ADDENDUM NO. 4

RFQ CCC-056

**New Student Services Building
Compton Community College District**

tBP Project. No. 20987.00

E2-1
 drawing of

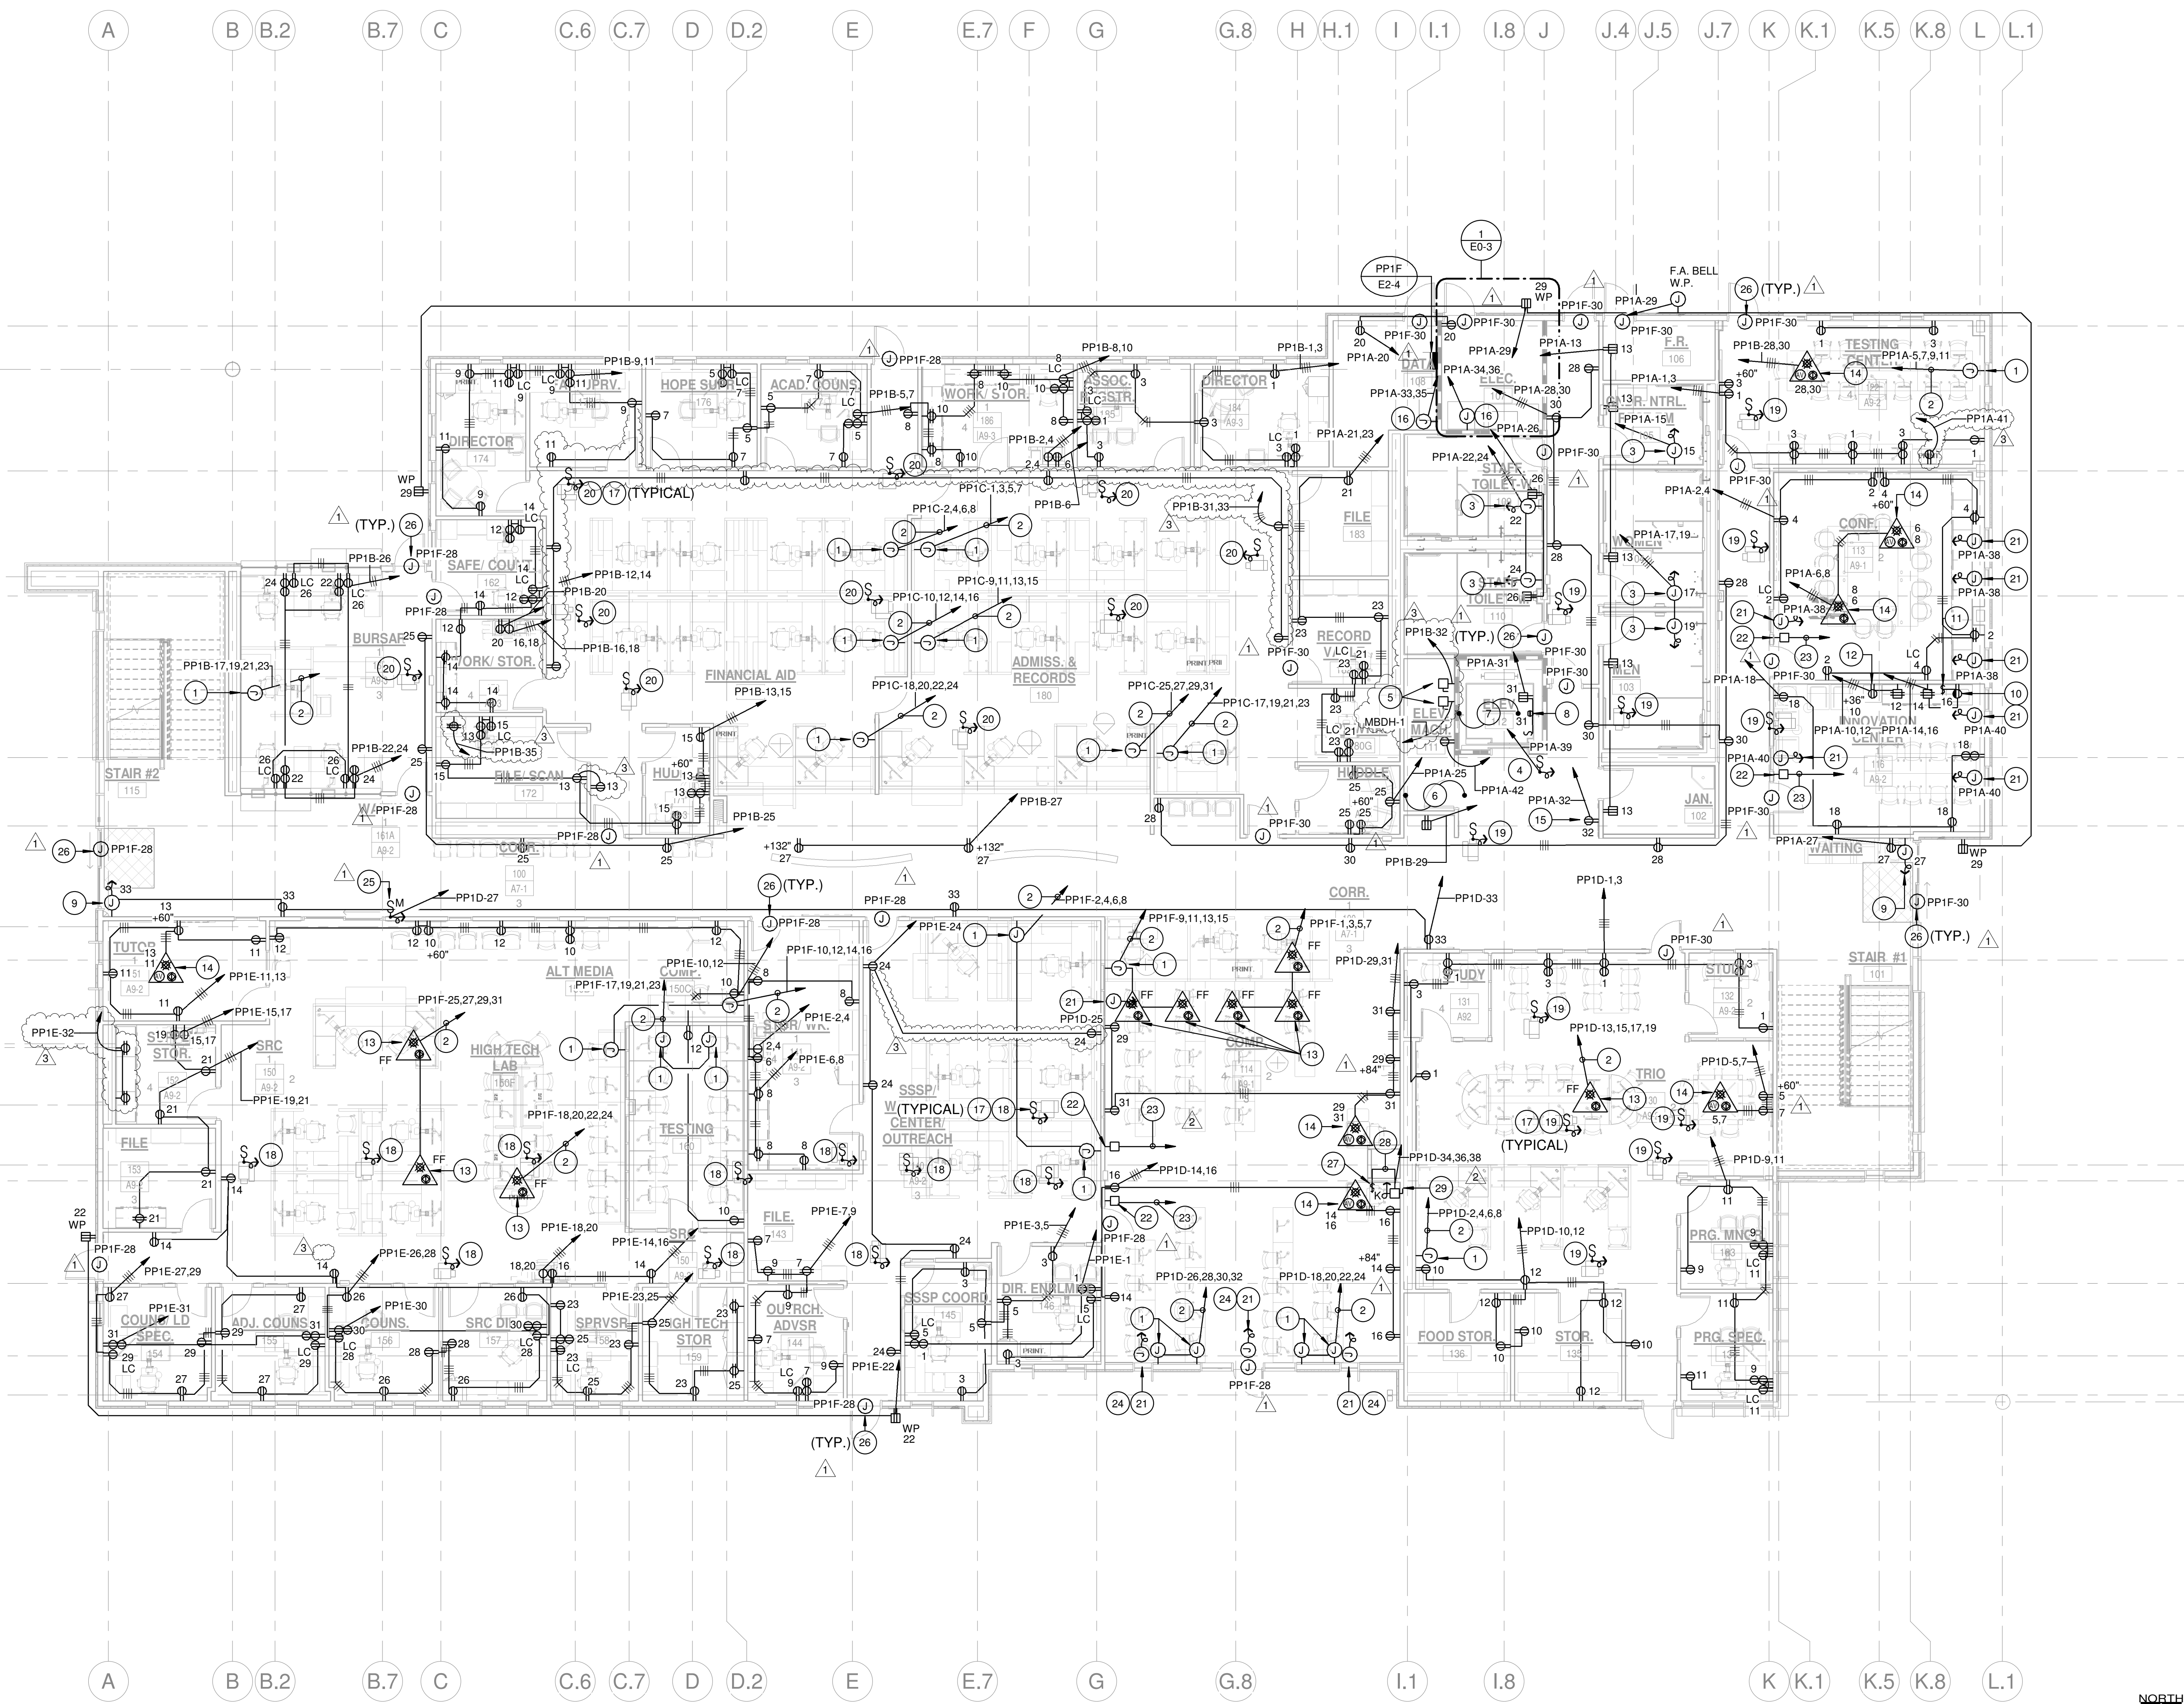
- a. Revise Elevator Machine Room 111 lighting circuit.
26. Revised SHEET E2-1 1ST FLOOR POWER PLAN
- a. Revise Power Plan per revised Drawing.

drawing title:
**FIRE ALARM RISER
 DIAGRAM**
 drawing no.:
EF-3
 drawing of

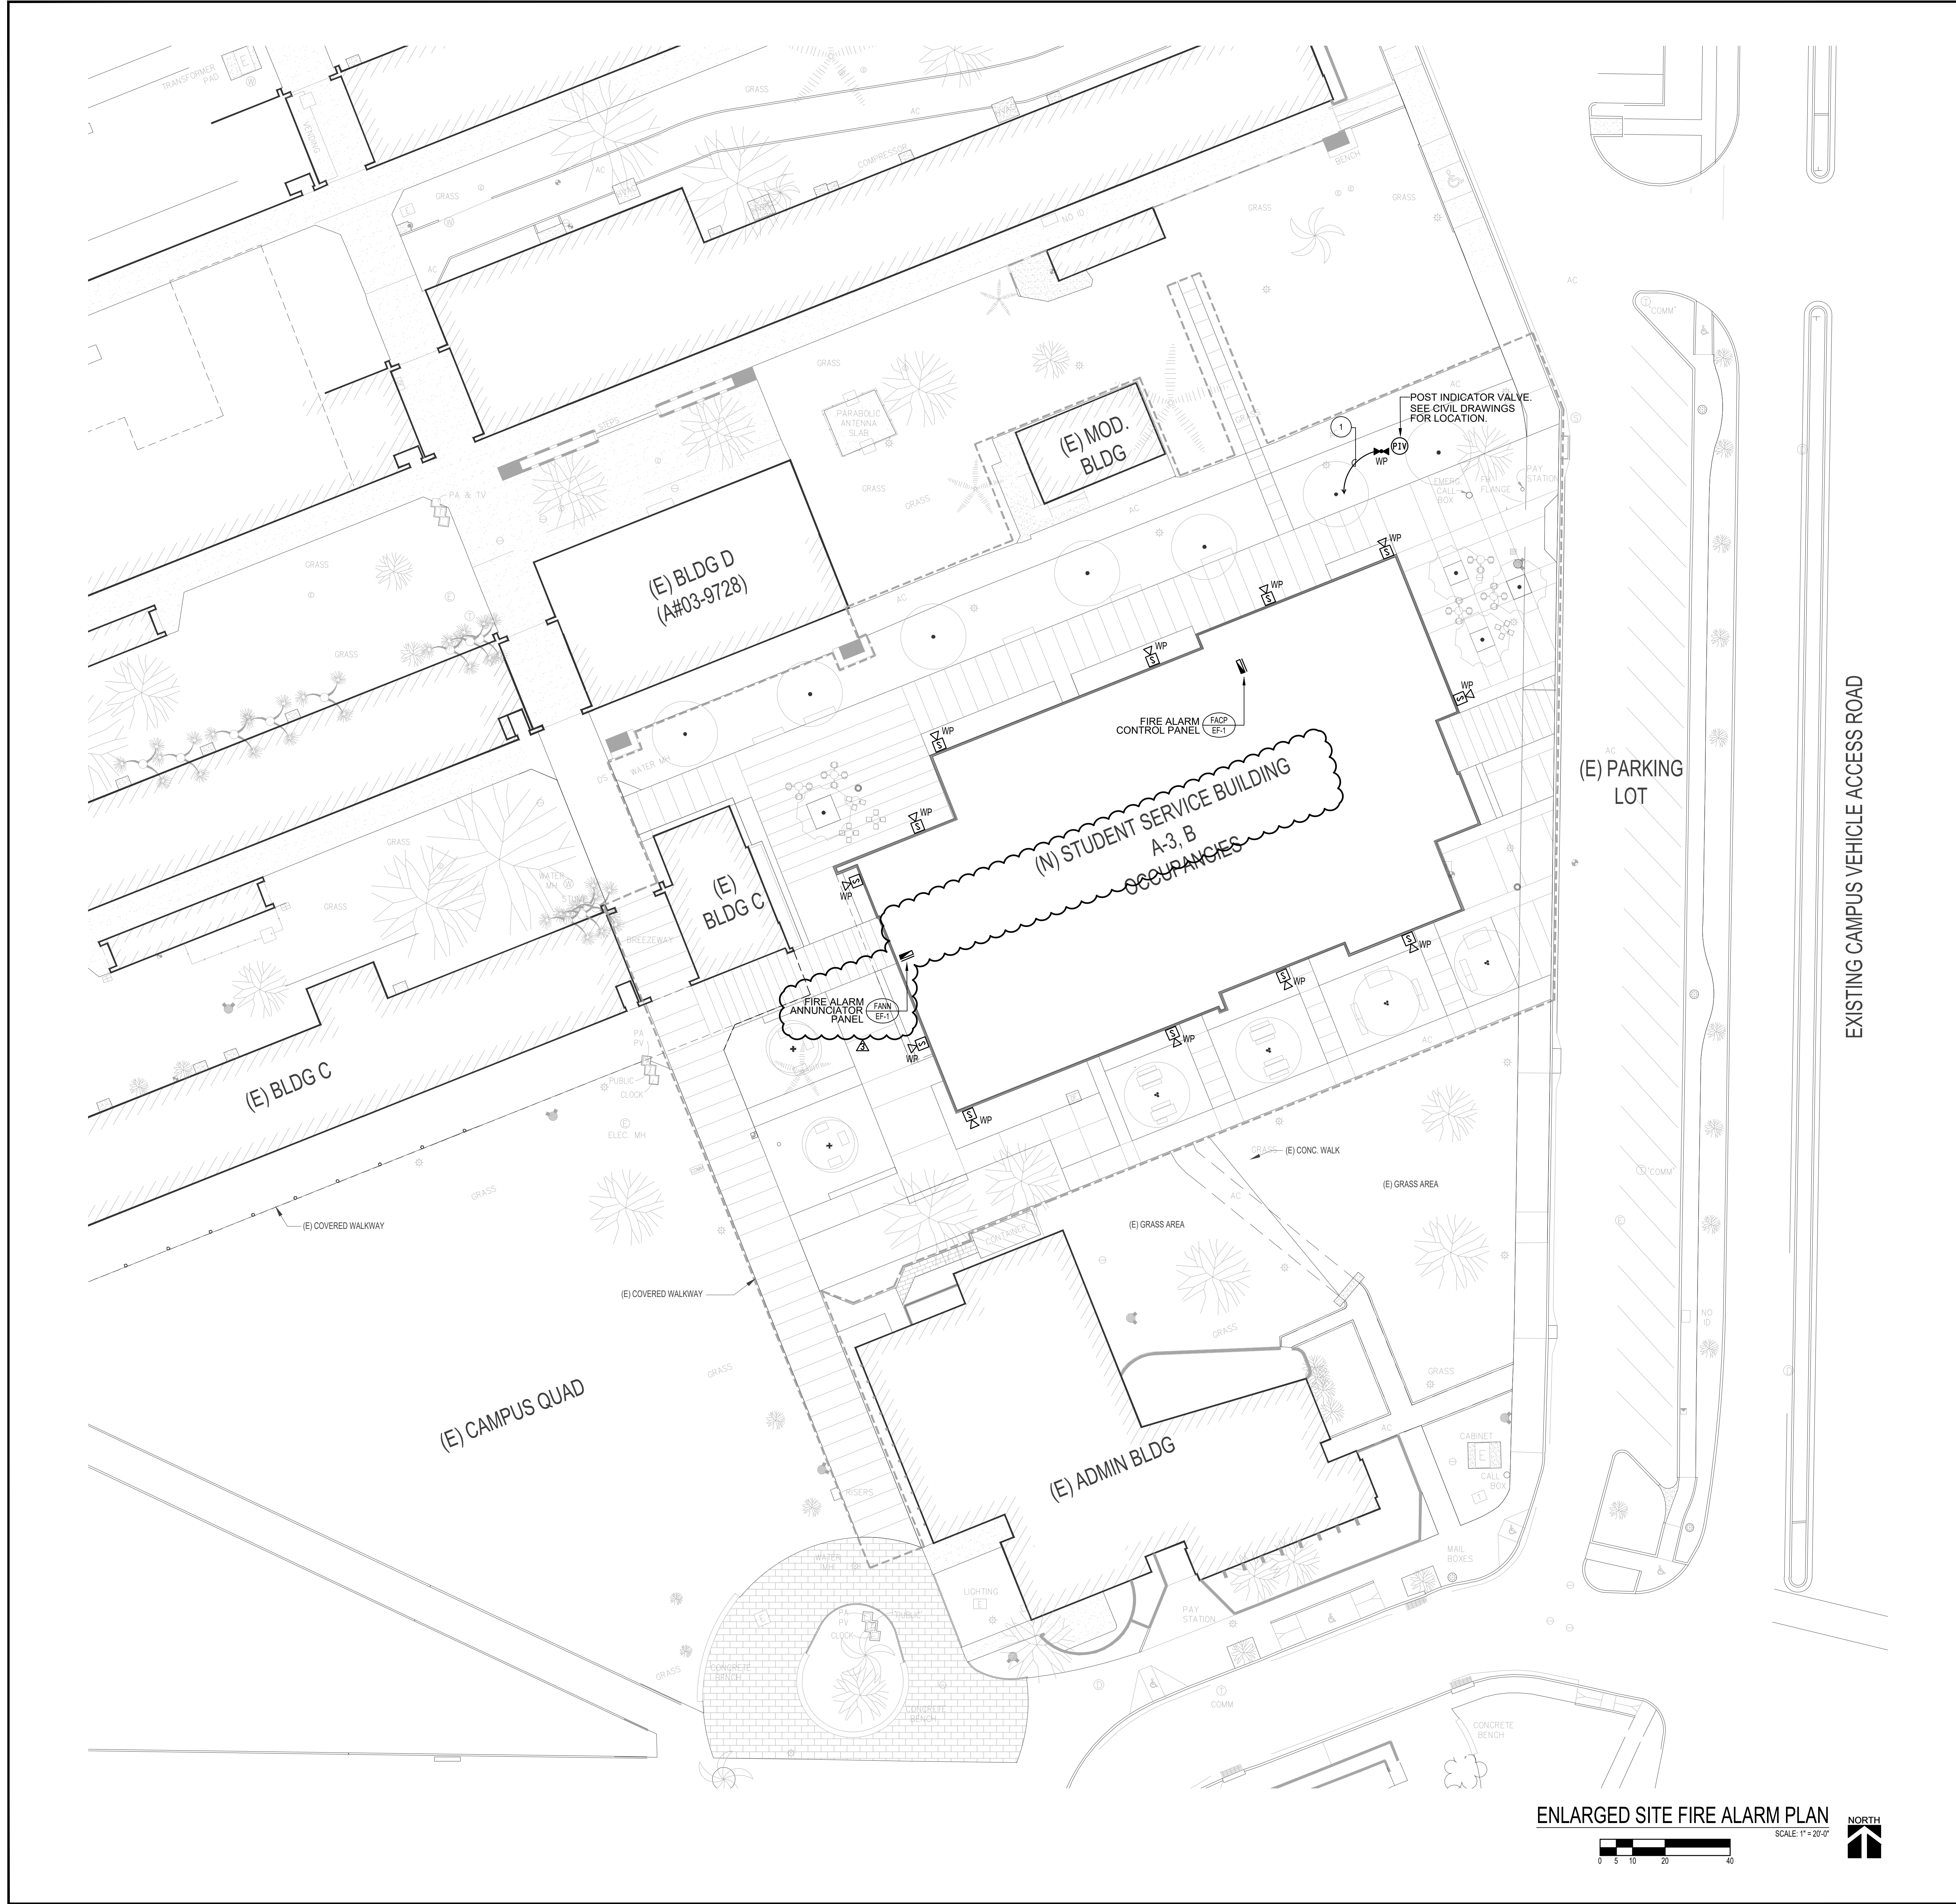
29. Revised SHEET EF-3 FIRE ALARM RISER DIAGRAM
 - a. Revised fire alarm riser diagram.
30. Revised SHEET EF-4 ENLARGED SITE FIRE ALARM PLAN
 - a. Revised annunciator location to match Fire Alarm Plan.

drawing no.:
EF-6
 drawing of

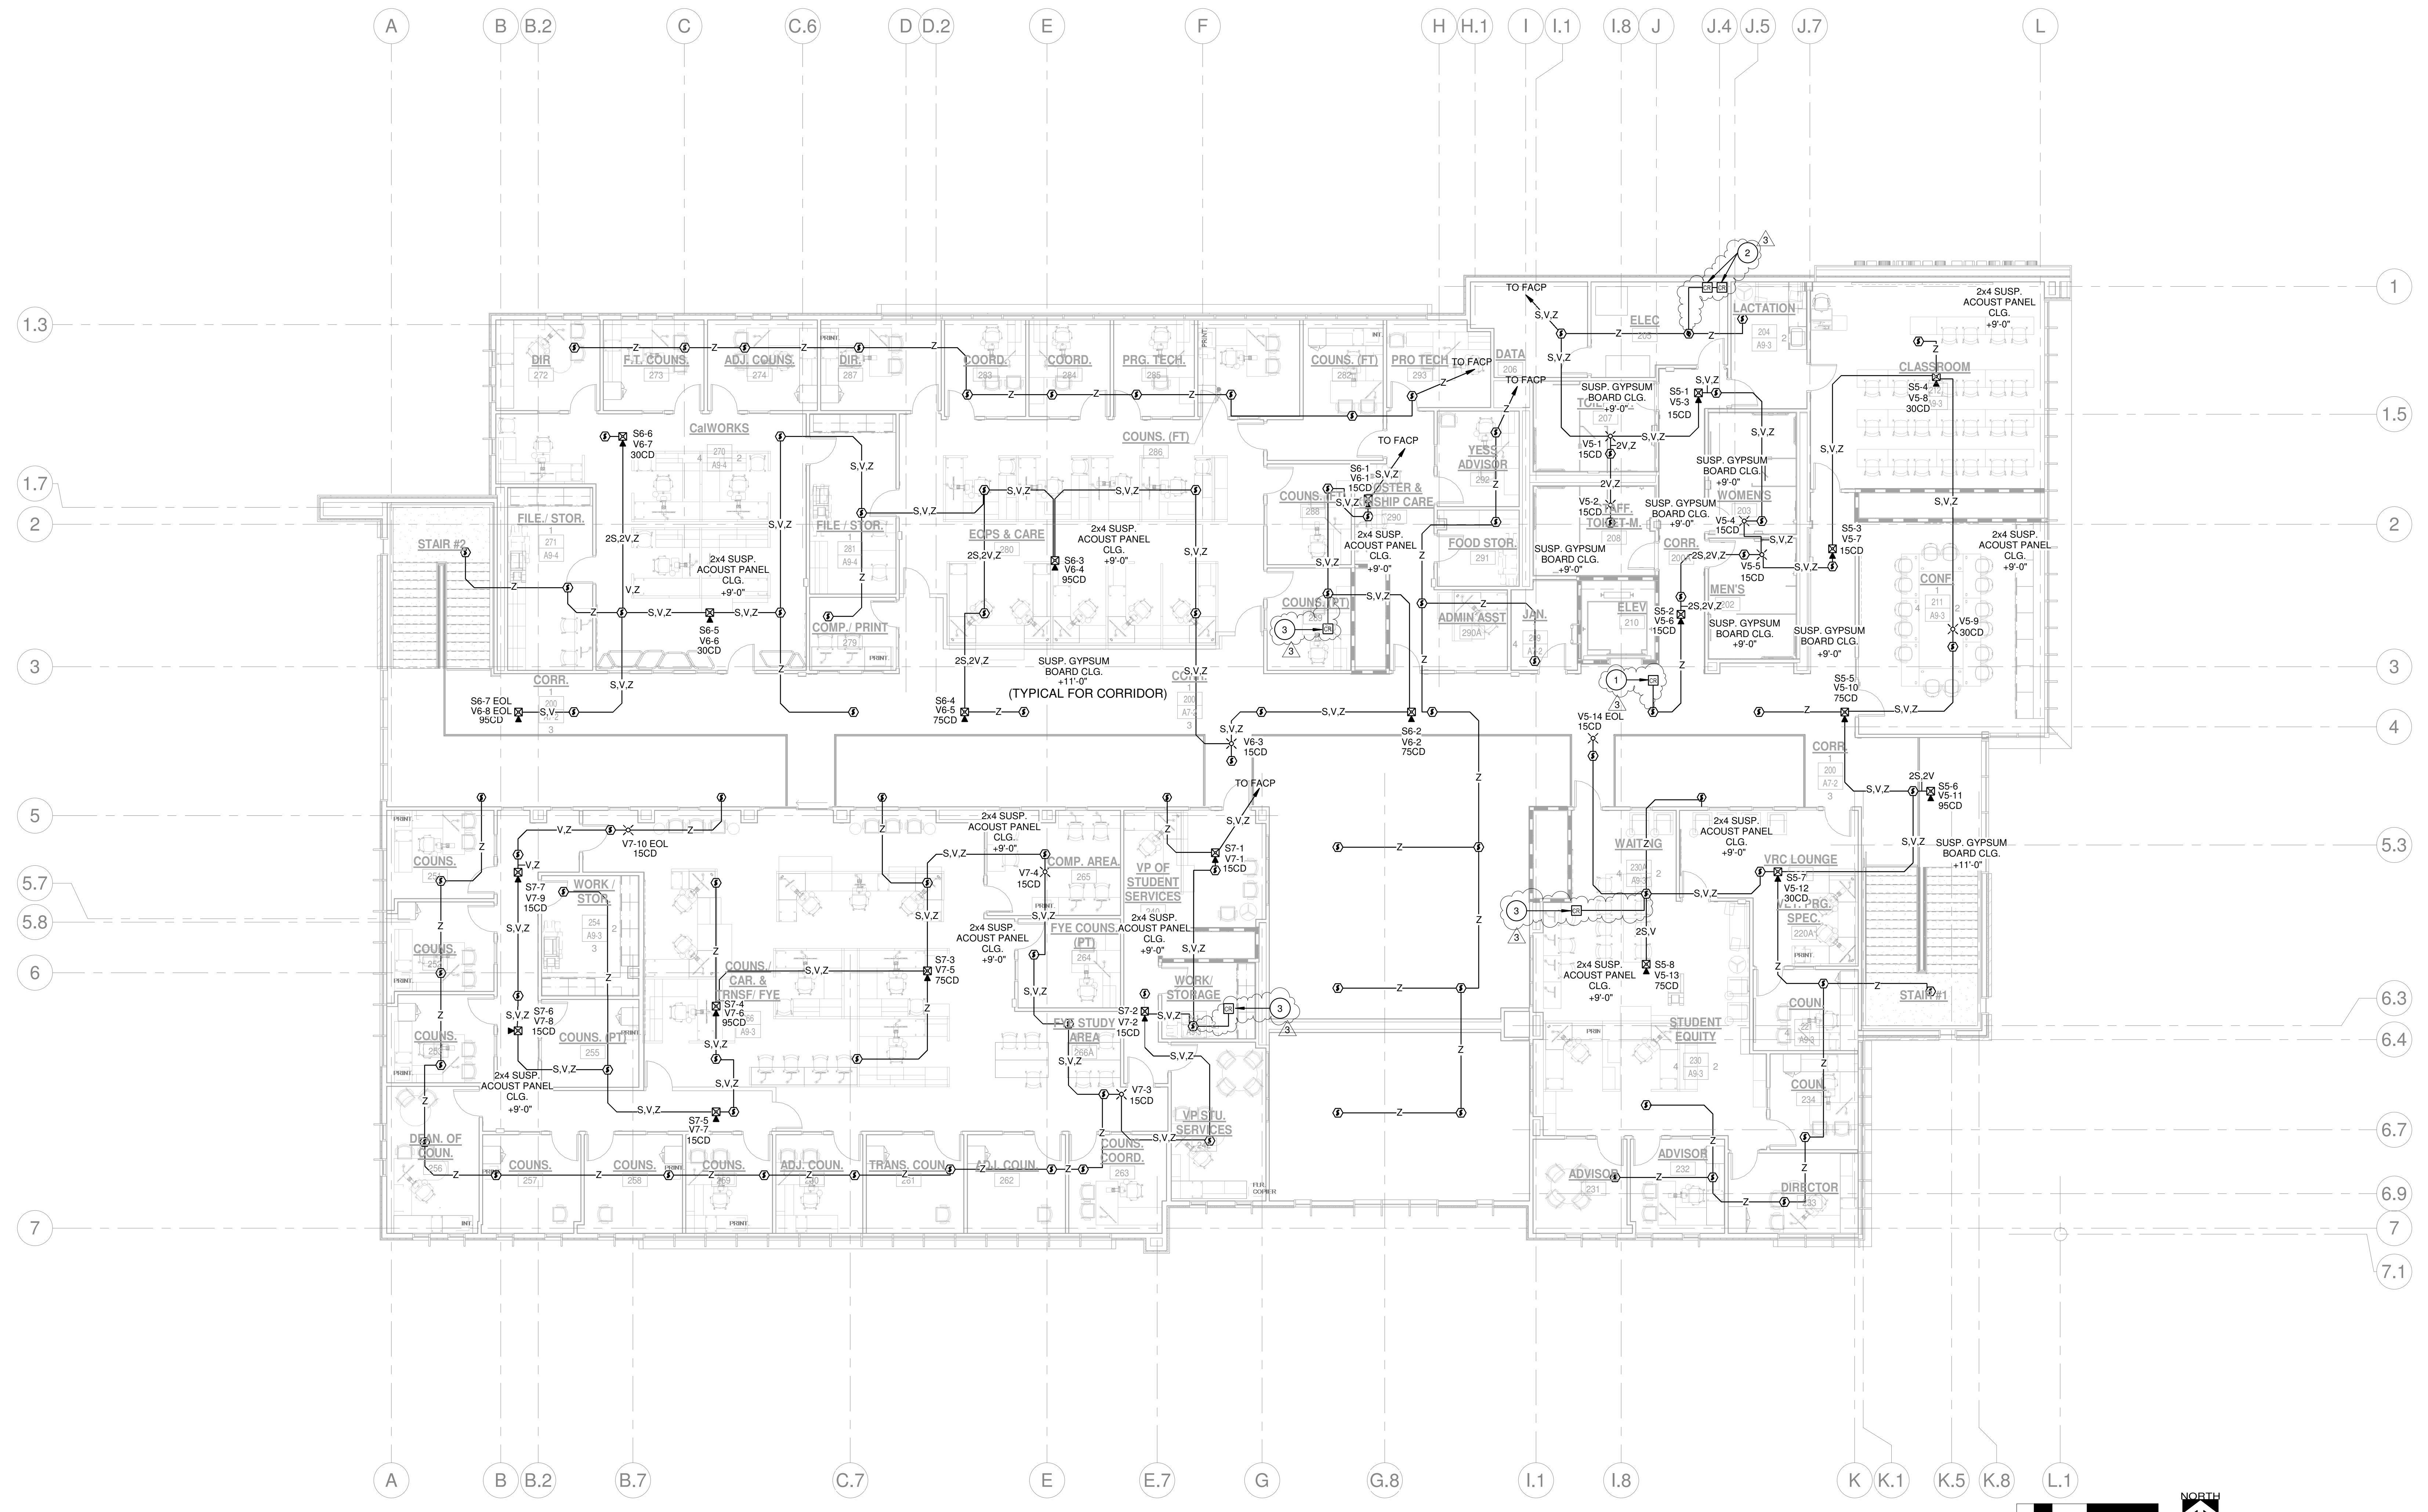
31. Revised SHEET EF-5 1ST FLOOR FIRE ALARM PLAN
 - a. Revised drawing to indicate fire damper alarm relays and elevator curtain.
32. Revised SHEET EF-6 2ND FLOOR FIRE ALARM PLAN

- a. Revised drawing to indicate fire damper alarm relays and elevator curtain.
33. Revised SHEET ET-1 TELECOM SYMBOL LIST NOTES AND DETAILS
 - a. Revised symbol list.
